**AGENDA
ARCHITECTURAL COMMISSION
REGULAR MEETING**

1) Consideration of a request for a new single-family home, 7237 Greywall Court and within the Concord Homes' Ravenna Planned Unit Development, submitted by Muhammad Khan, the future homeowner.

PROJECT: PROPOSED NEW RESIDENCE
 7237 GREYWALL COURT (LOT 96)
 LONG GROVE, IL 60047

FRONT ELEVATION

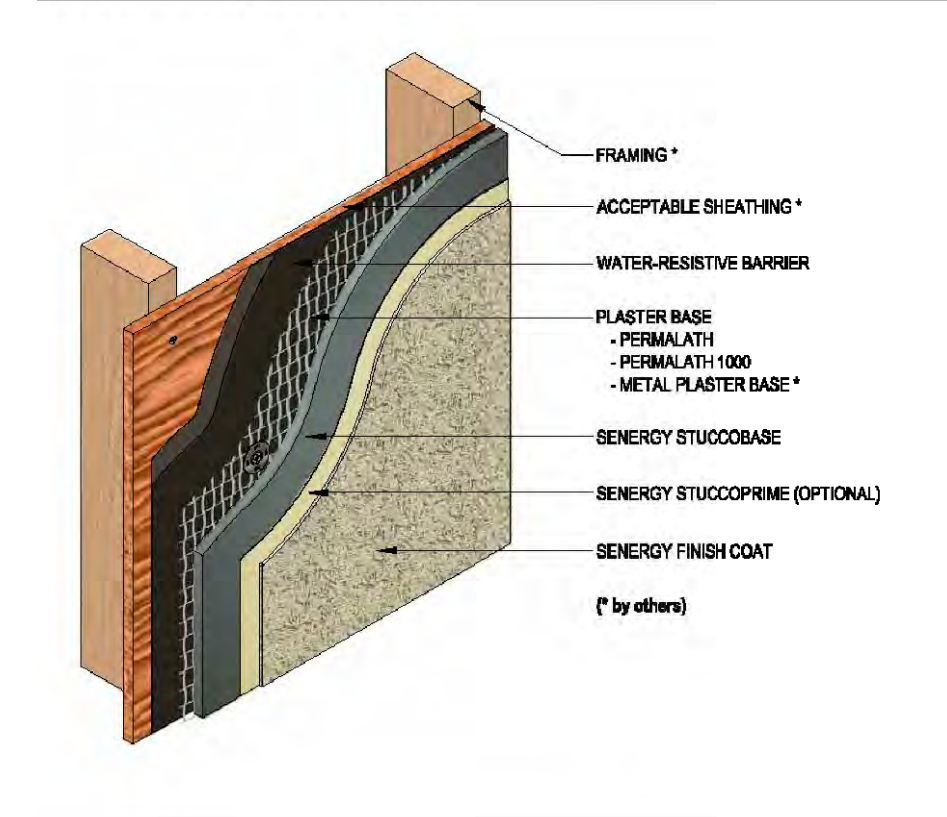
The commission has also noticed the large amount of stucco used on the front façade of the proposed residence while most of the residences on Greywall Court are constructed out of masonry. Commissioner Roiter added there is a lack of stucco and all the other elevations.

Chairwoman Sylvester drove through this neighborhood and mentioned that other residences use a variety of different materials and rooflines. She thinks the proposed residences would better fit in this neighborhood's style by breaking up the massive flat face planes with different materials or ornamentations.

1- We will do cedar shake shingles per plan attached. 2- Stone will be provided just as it shows on then drawings 3- The chimney was added to the Drawings, please see attached drawings 4-Please see attached stone picture. 5- The material colors were provided on the initial submission of documents. 6-We are working on the plan, but if you can approve the permit we will provide later. 7- The Rear elevation was updated with the sliding on the living room.

LEFT ELEVATION

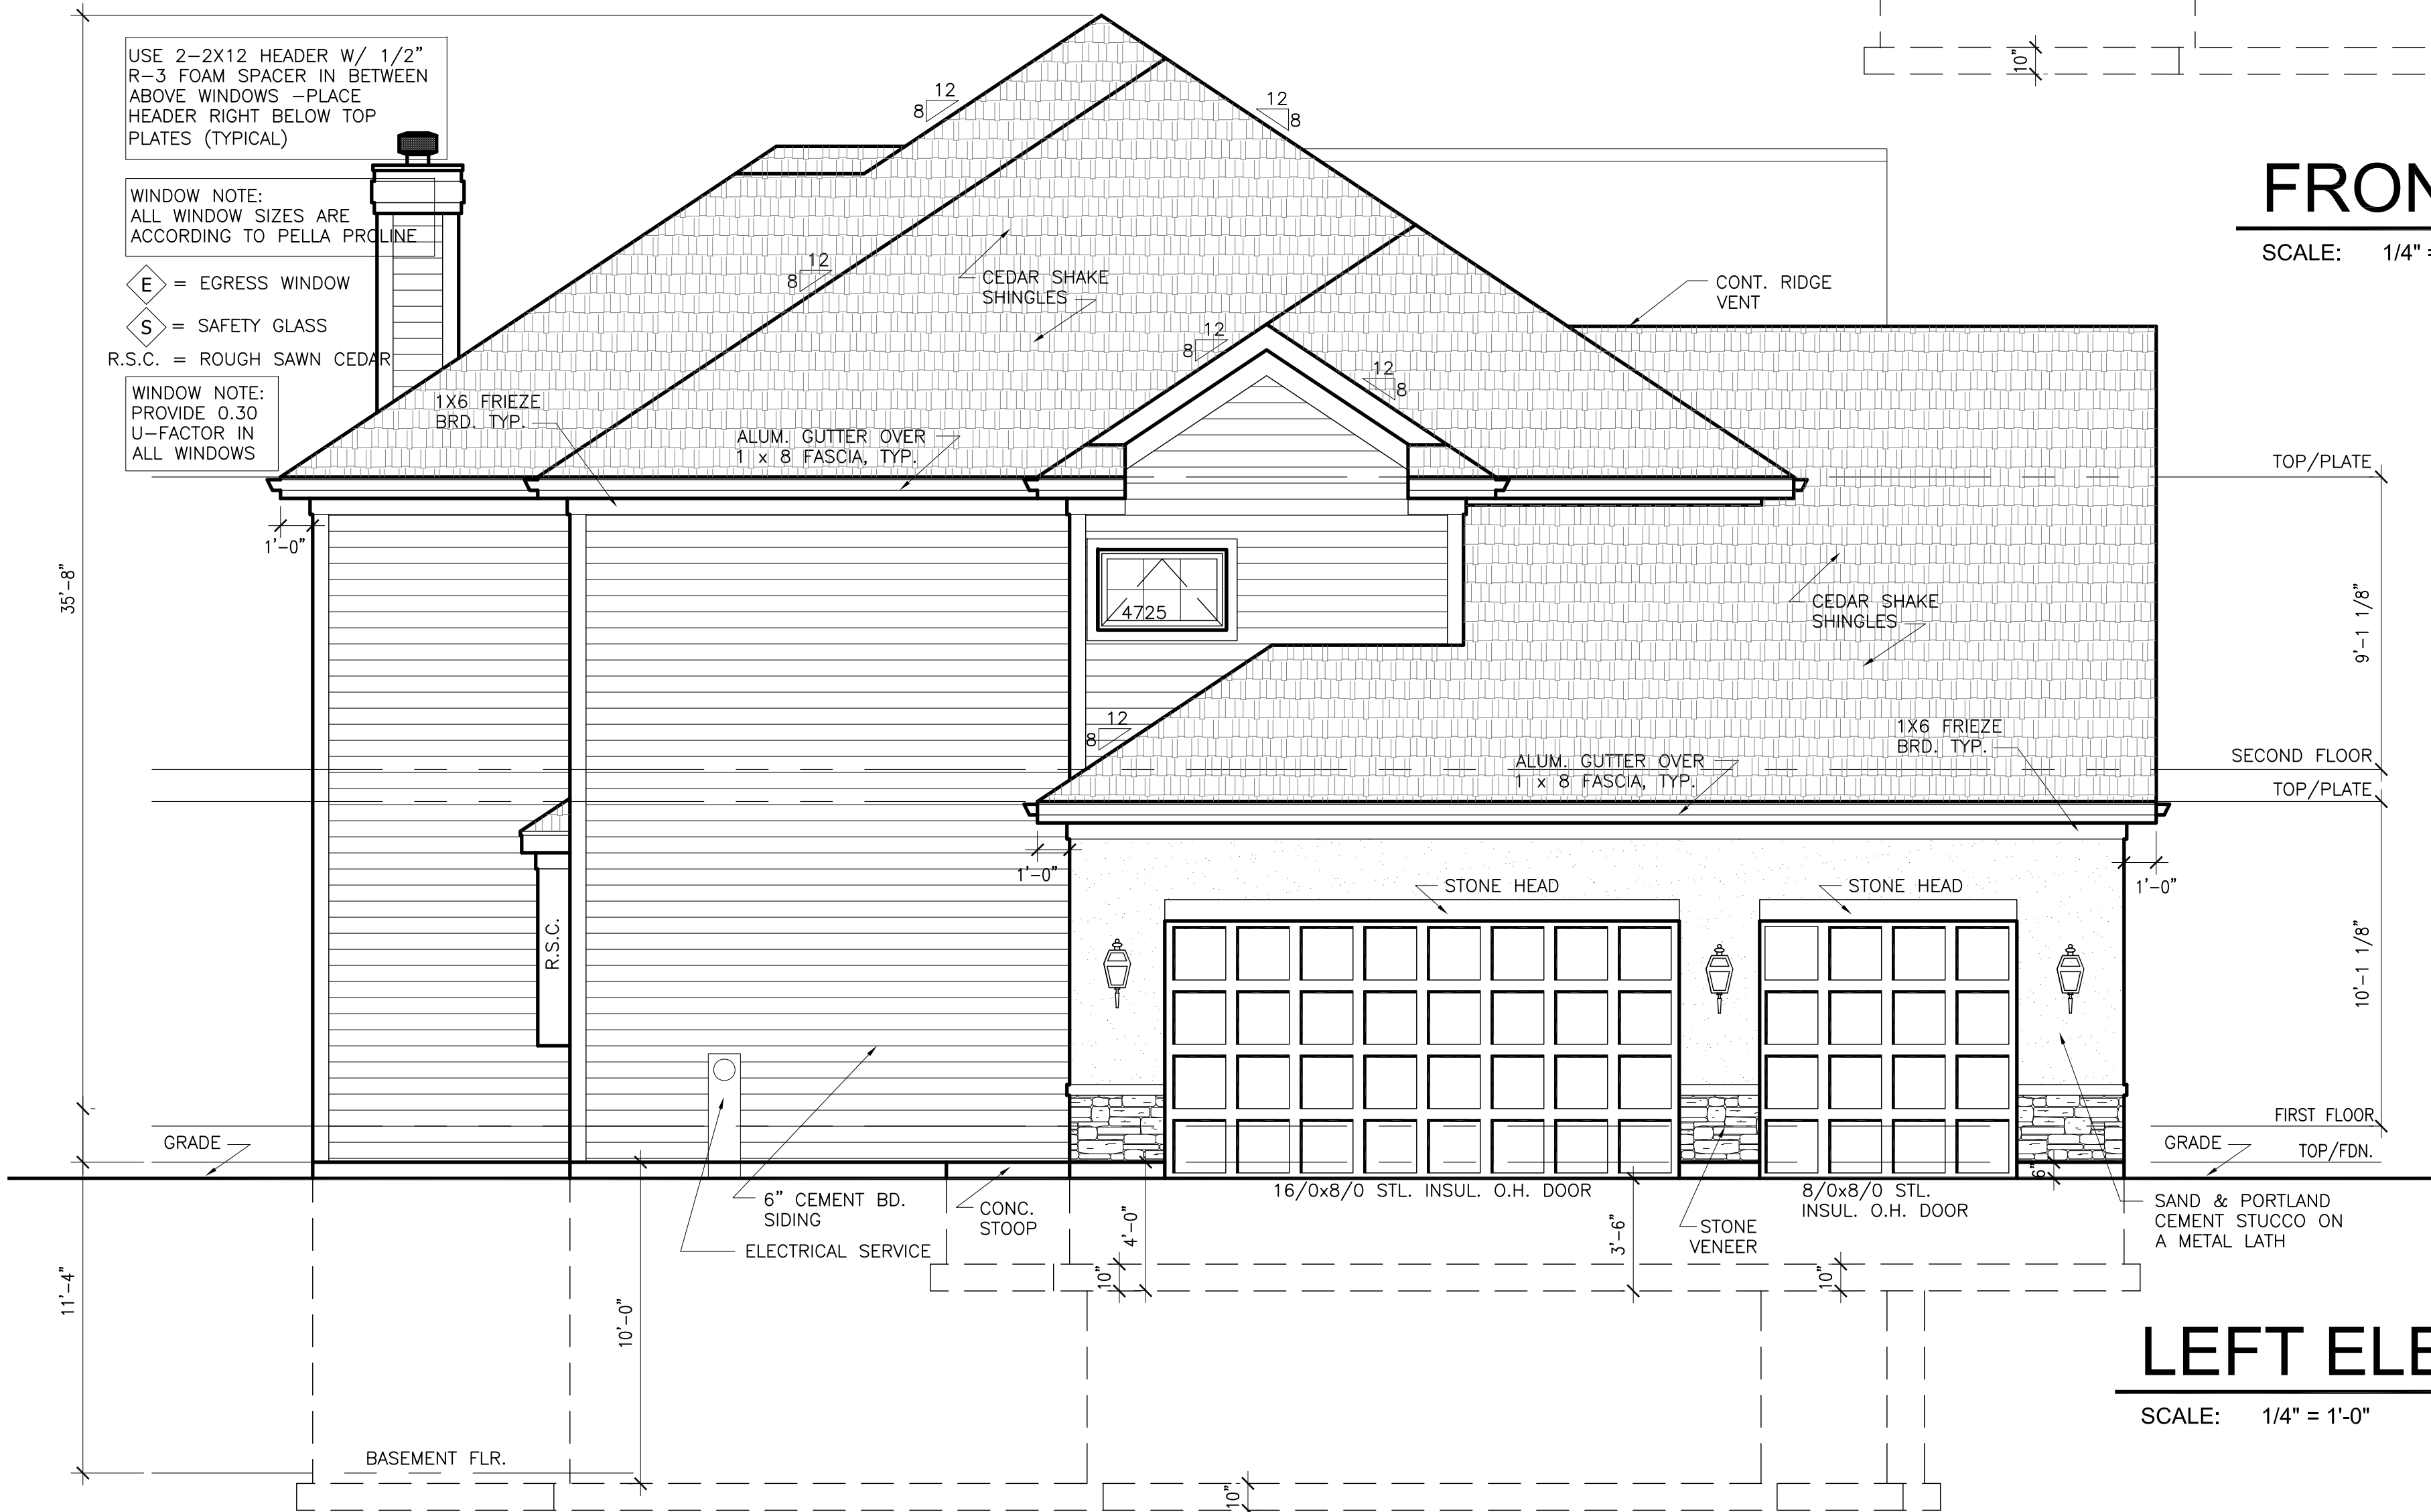
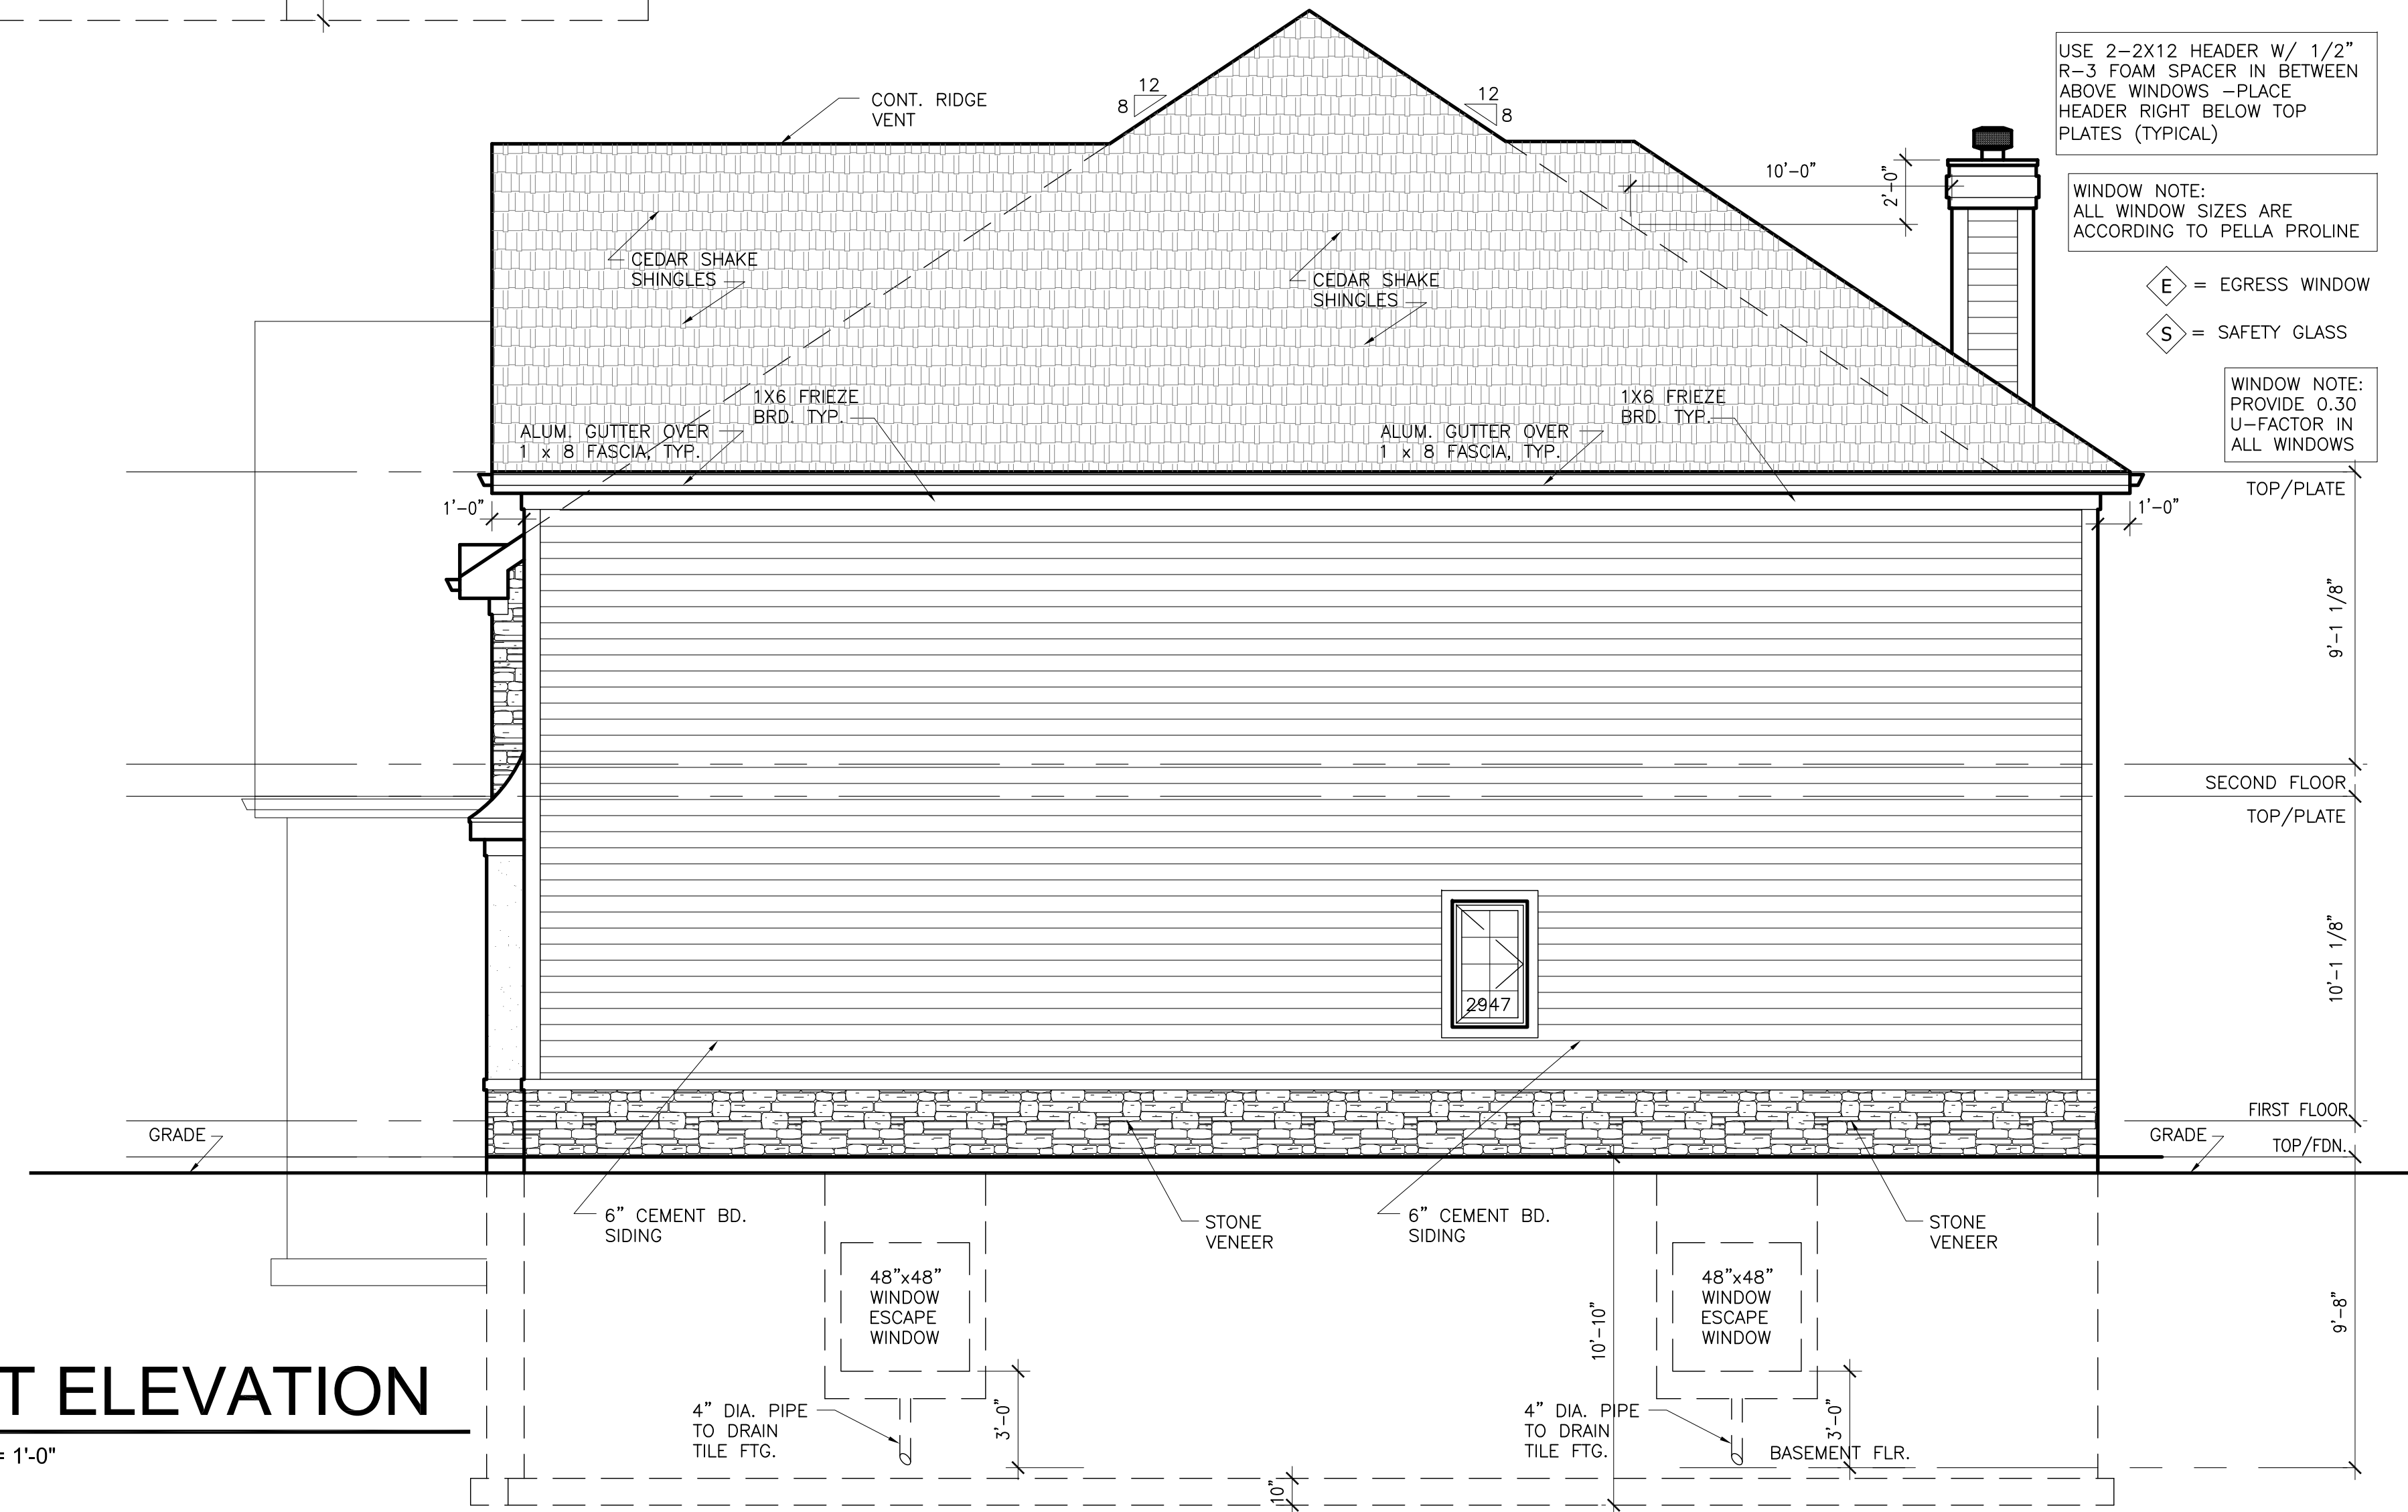
Chairwoman Sylvester had concern with the lack of variety of building materials on the left and right elevation. Commissioner Roiter agreed with her and added there is only one window on those elevations as well. He furthered explained that with new construction all four elevations should have a fair number of windows to provide consistency with the front and rear elevations. Commissioner Marshall wondered why the homeowner wouldn't want to have more windows on the other side of the living room since it isn't a private room.

- The Commission had concerns about the lack of variety and consistency of materials and windows on the left, right, and rear elevations. Most of the residences in this neighborhood used a variety of different materials and rooflines. The Commissioners' suggested breaking up the massive flat face planes with different materials or ornamentations. Per the Anti Monotony Ordinance, the commission will not be recommending elevations with majority of the residences being siding. The Commission strongly encourages the applicant to incorporate the materials and windows used on the front façade into the remaining three façades.
